PLANNING COMMISSION AGENDA

1. JSP25-0031 ARMENIAN CHURCH AND CULTURAL CENTER

1. JF26-05 LIFETIME FITNESS FACADE

Attachment A
Site Photographs

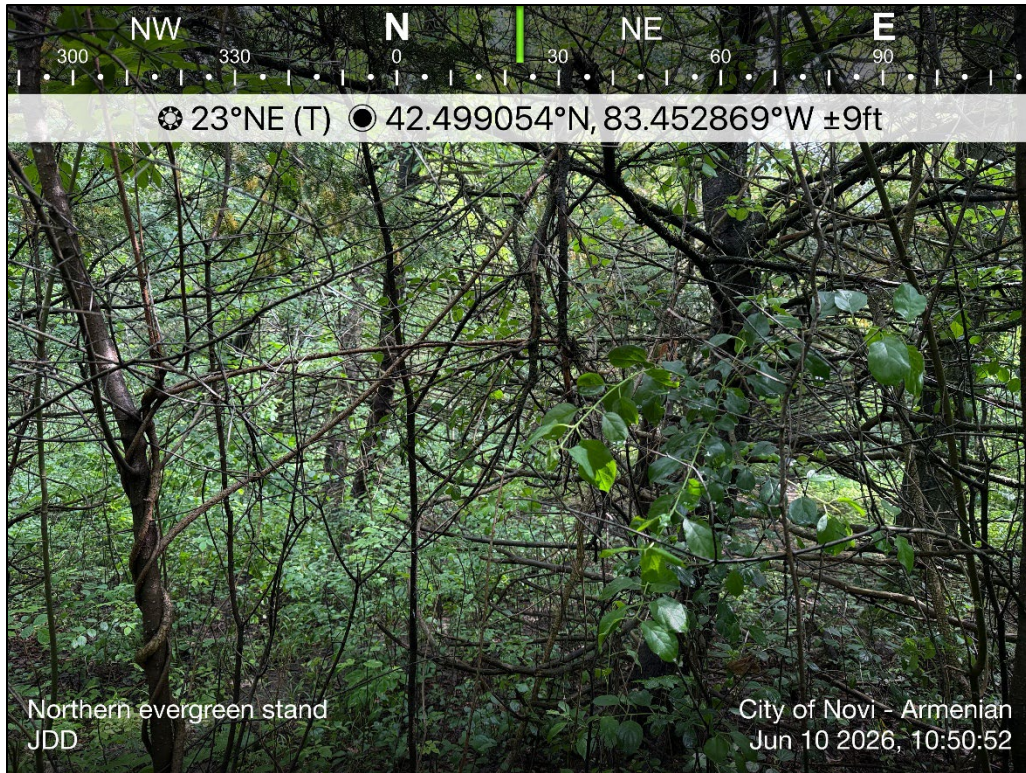
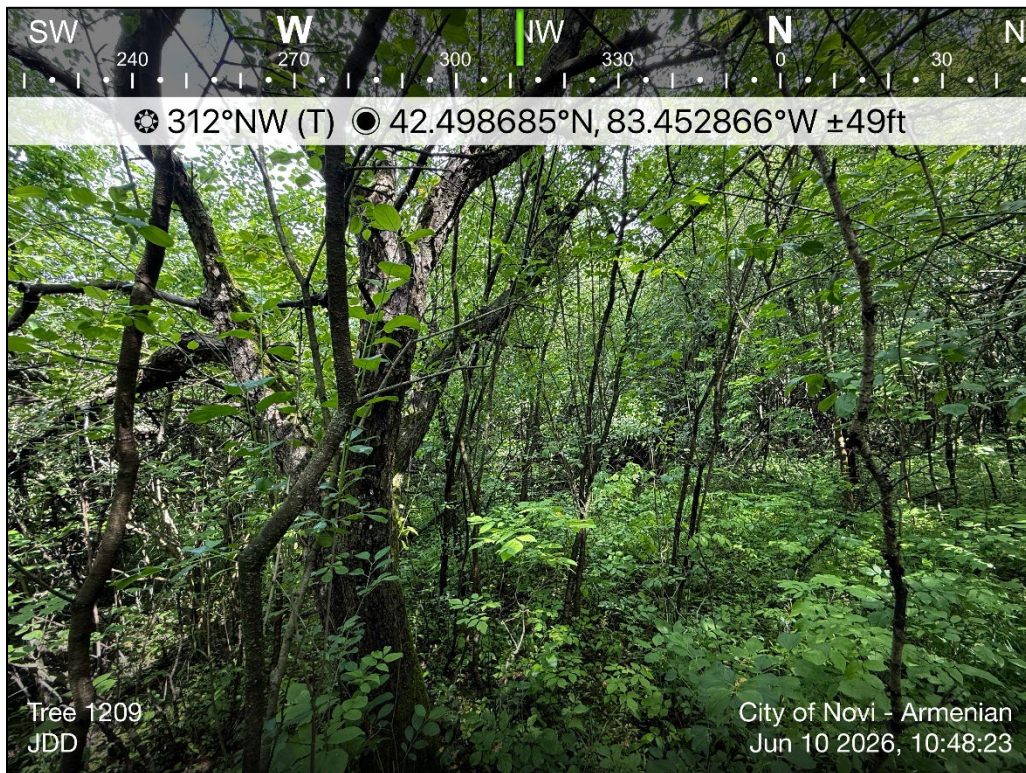
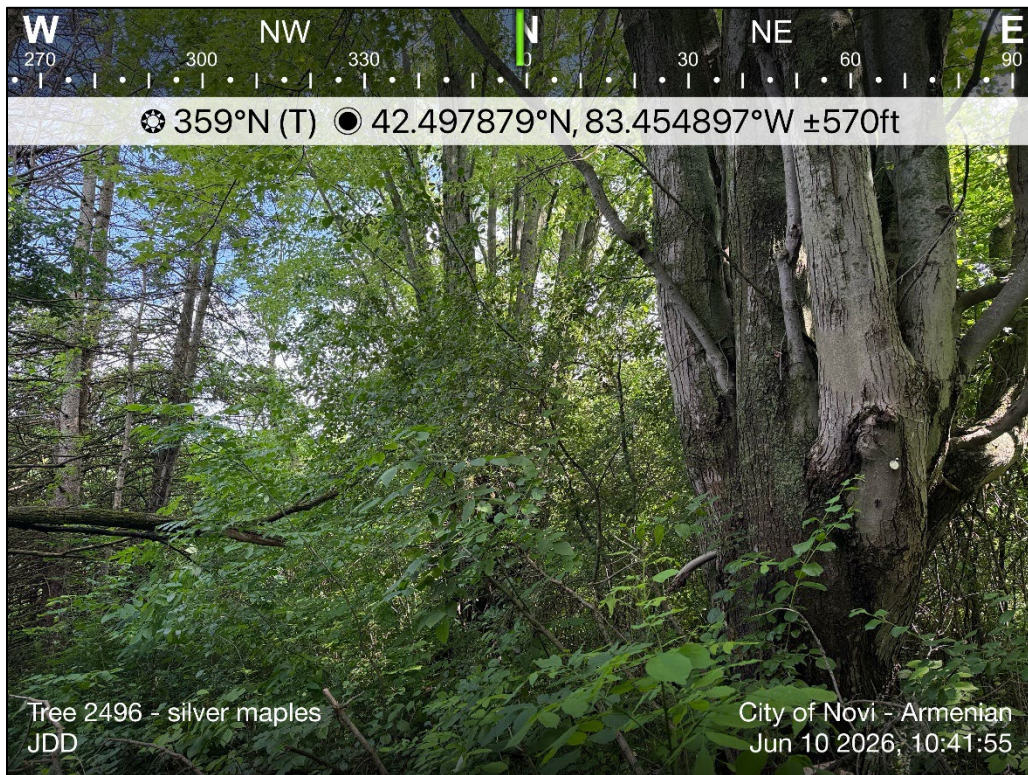
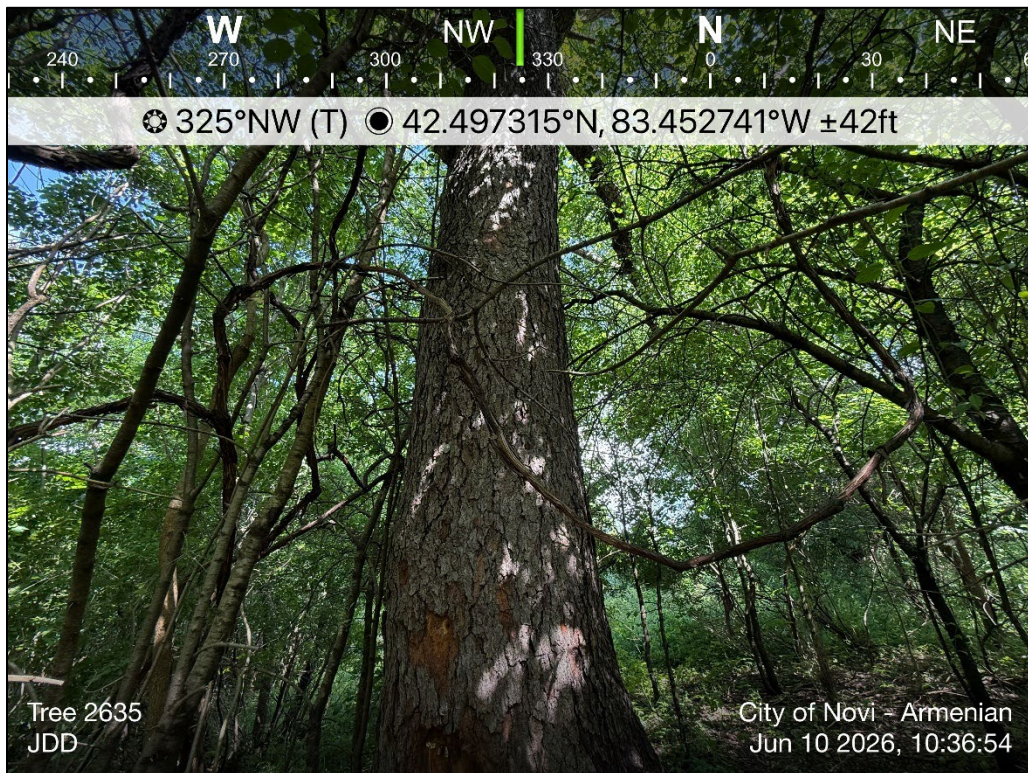
Overview of the northern evergreen stand that was not previously tagged

Overview of Tree 1209

Overview of the spruce stand at Tree 1763

Overview of Tree 2496 and the stand of nearby silver maples

Overview of Tree 2632

Overview of Tree 2635

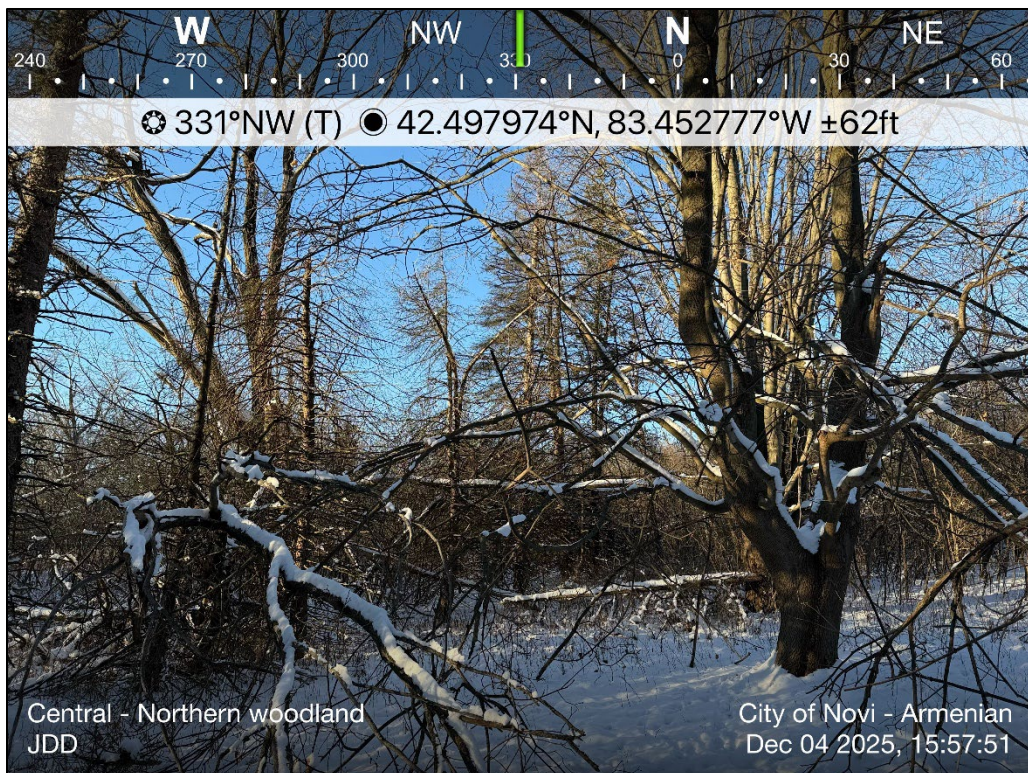
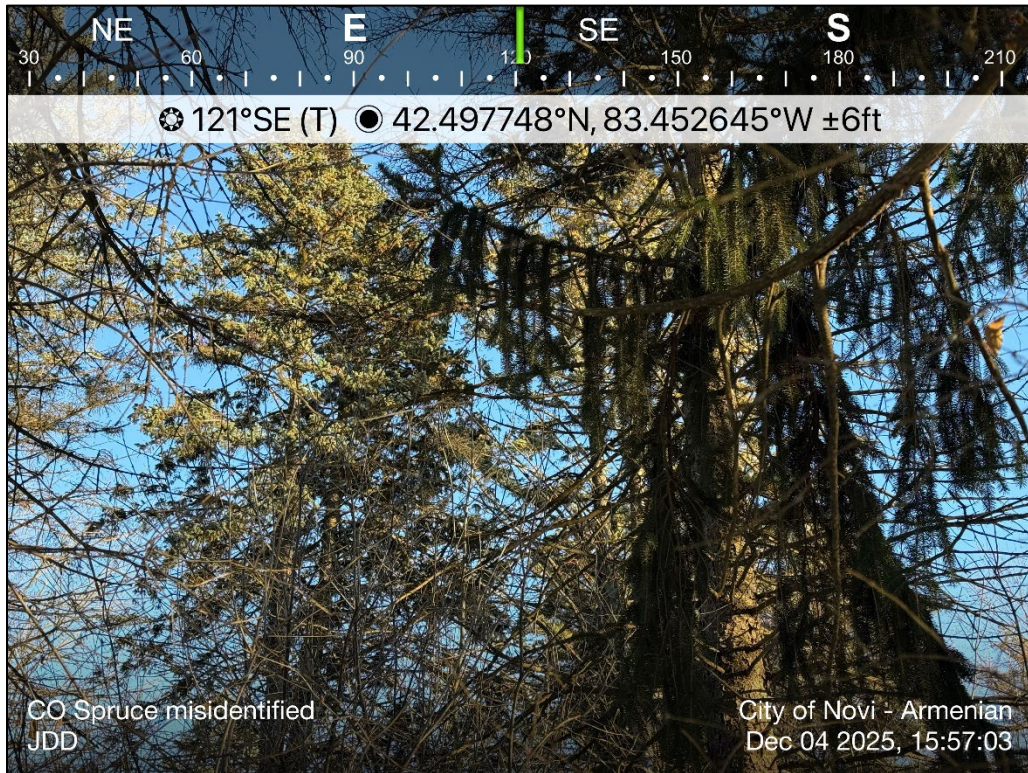
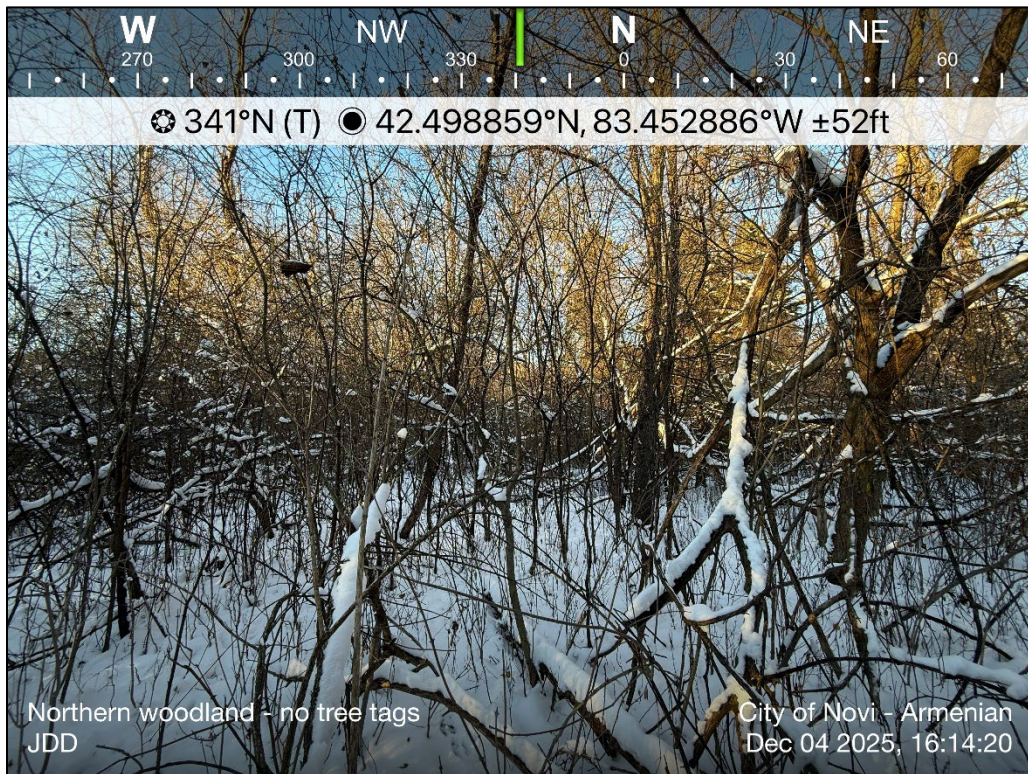
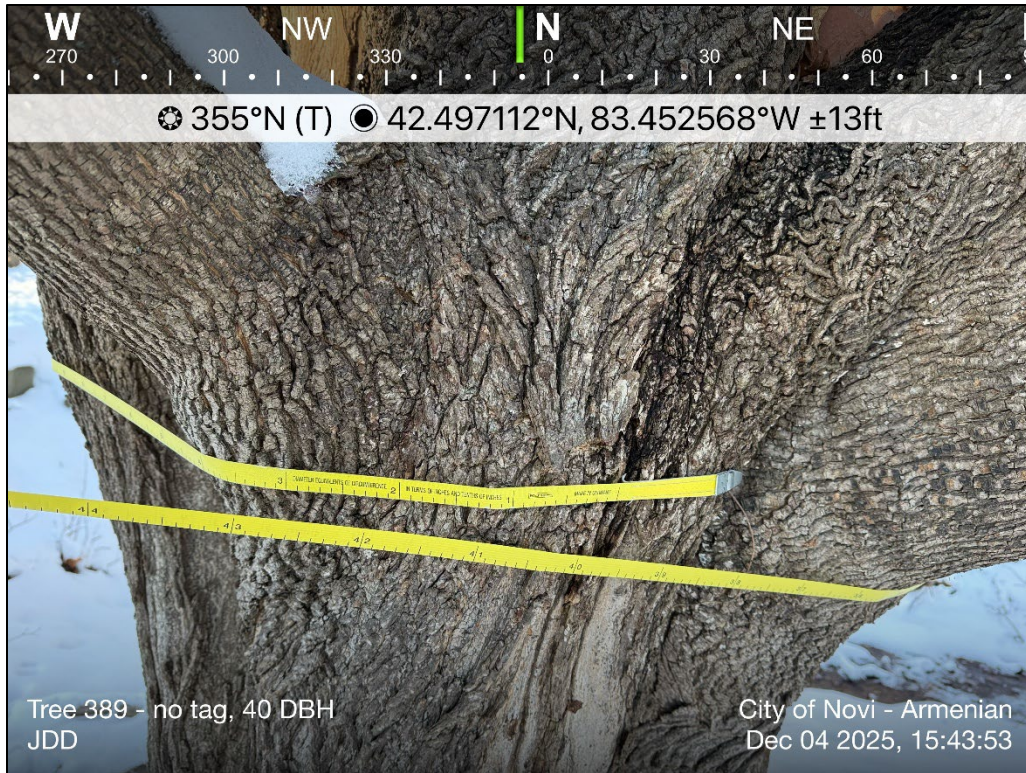
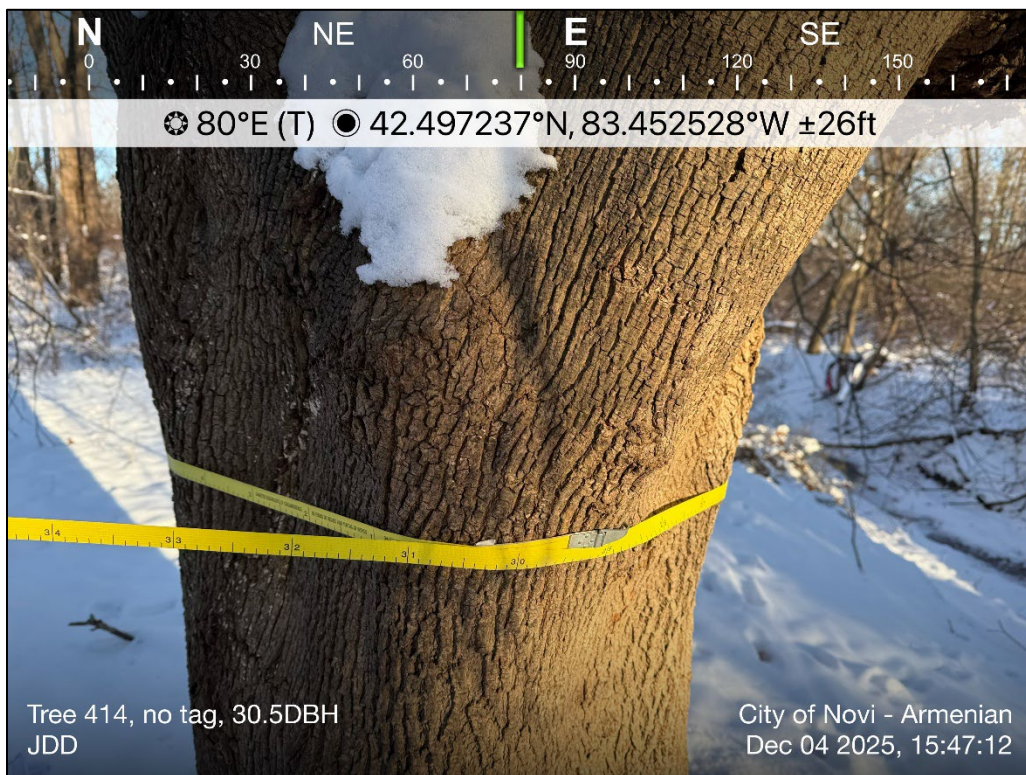
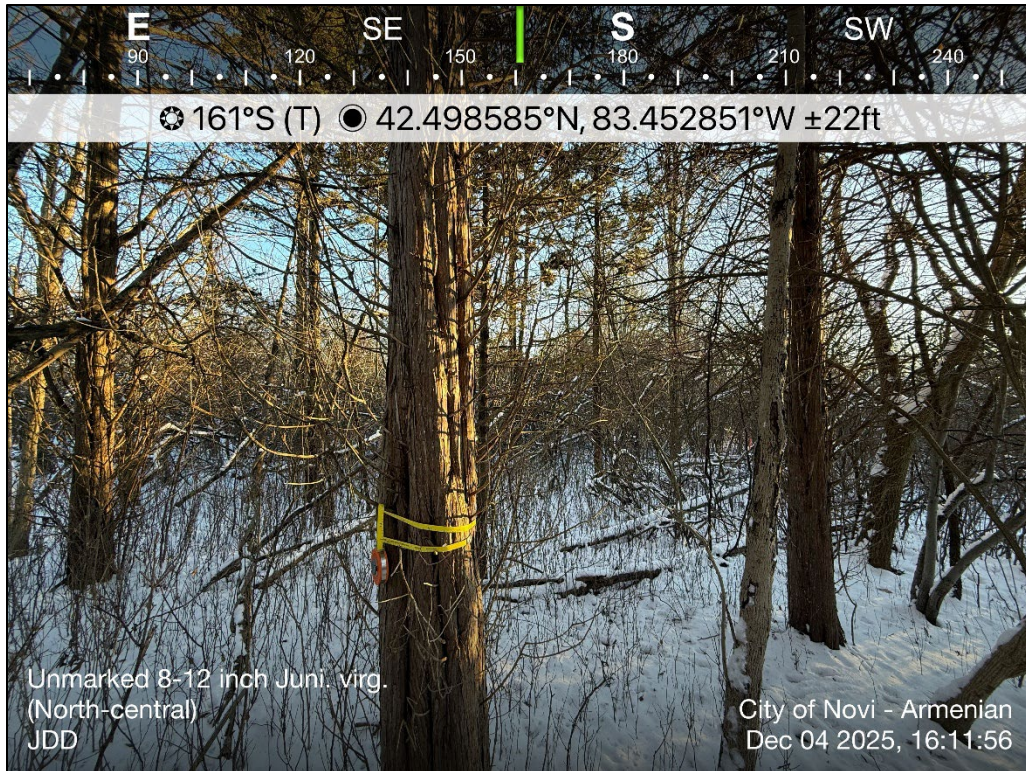
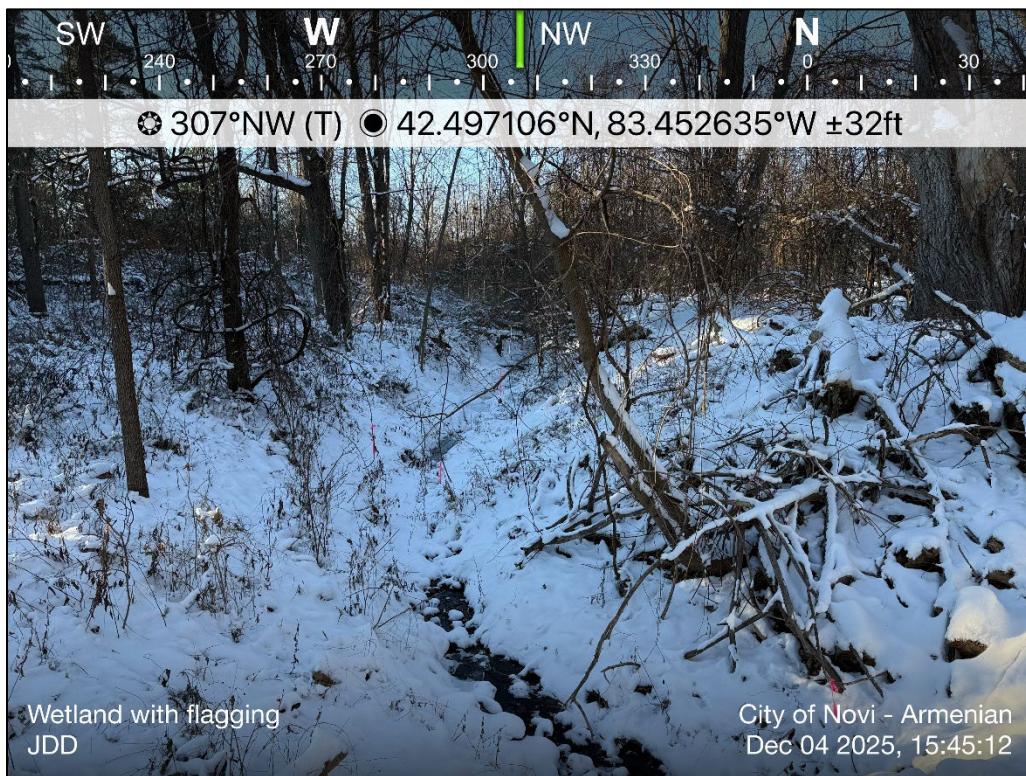
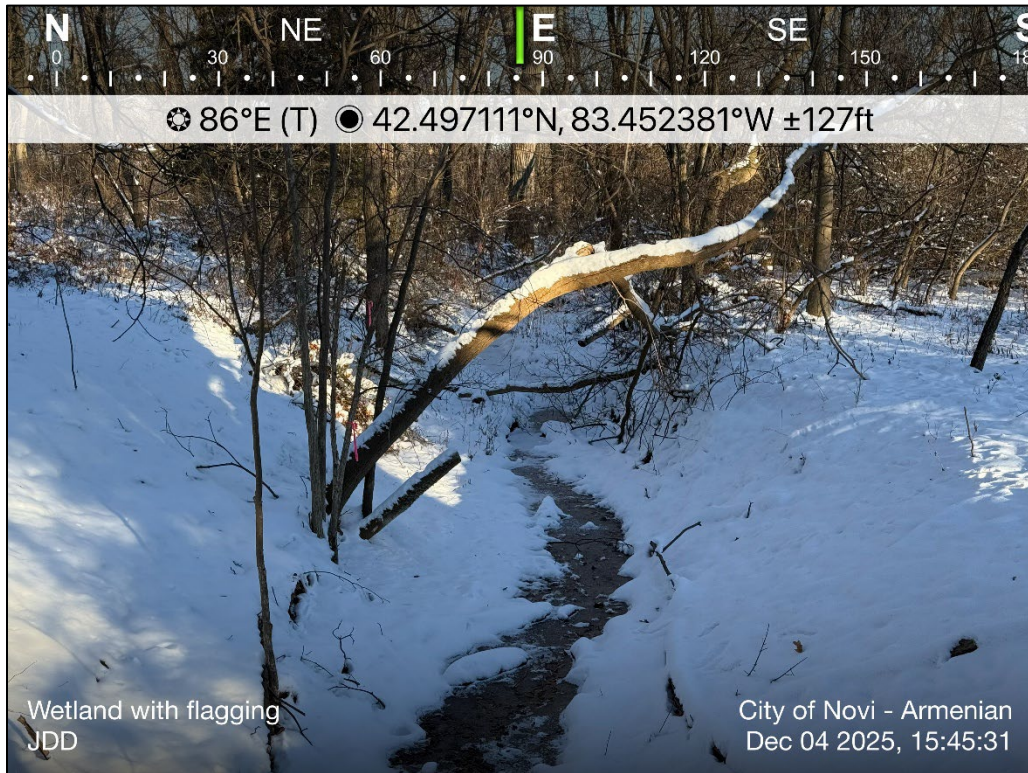
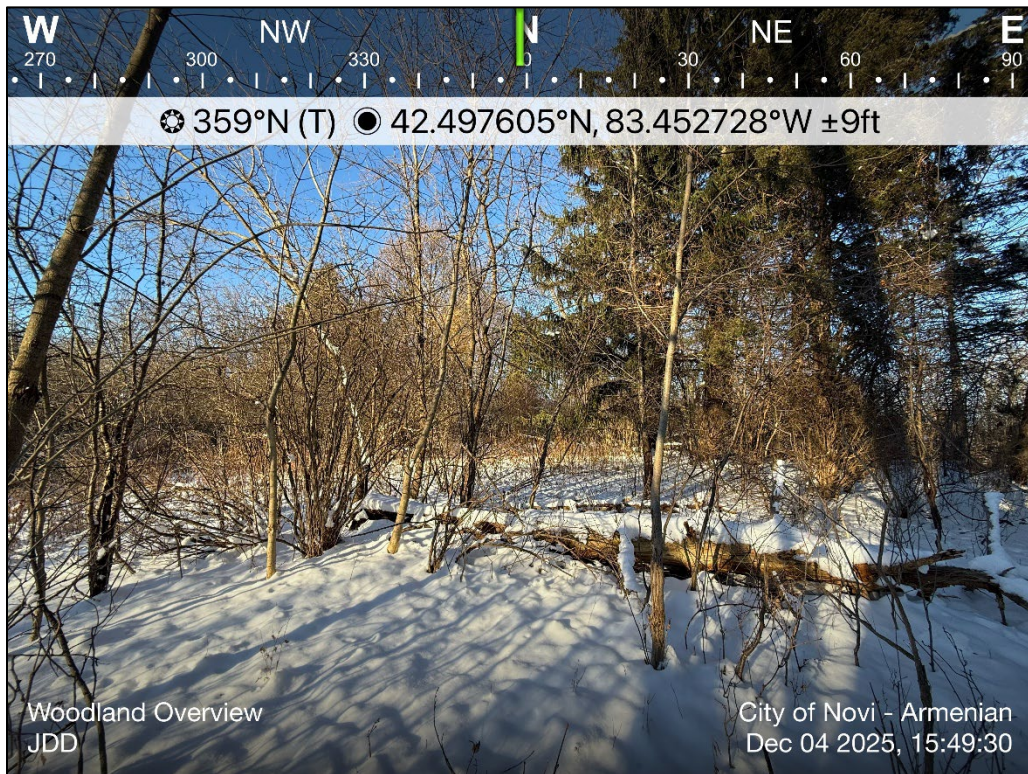
A measured 27-inch DBH sugar maple (*Acer saccharum*) that was assumed to be at or near Tree 110 with no tree tag or identification on-site.

Captured approximately near Tree 460, this maple was measured to be 42-inches DBH. No trees in the tree survey (excluding the large willows) were measured with this large of DBH. No tree tags or identifiers present.

Measured at the approximate location of Tree 474, no coniferous trees near Tree 474 were measured to be this large. No tree tags or identifiers were present.

Some Norway spruce (*Picea abies*, foreground) trees on-site may have been misidentified as Colorado blue spruce trees (*Picea pungens*).

Overview of the northern woodland area with no tree tags or identifiers found

Overview of the southern woodland area with no tree tags or identifiers found

Likely Tree 389 (no identification present on-site), which was identified as having a DBH of 30-inches was measured to have a DBH of 40-inches on-site.

Likely Tree 414 (no identification present on-site), which was identified as having a DBH of 24-inches was measured to have a DBH of 30.5 (31)-inches on-site.

A large stand of unmarked 8-12 inch DBH eastern red cedar (*Juniperus virginiana*) trees in the north-central portion of the site.
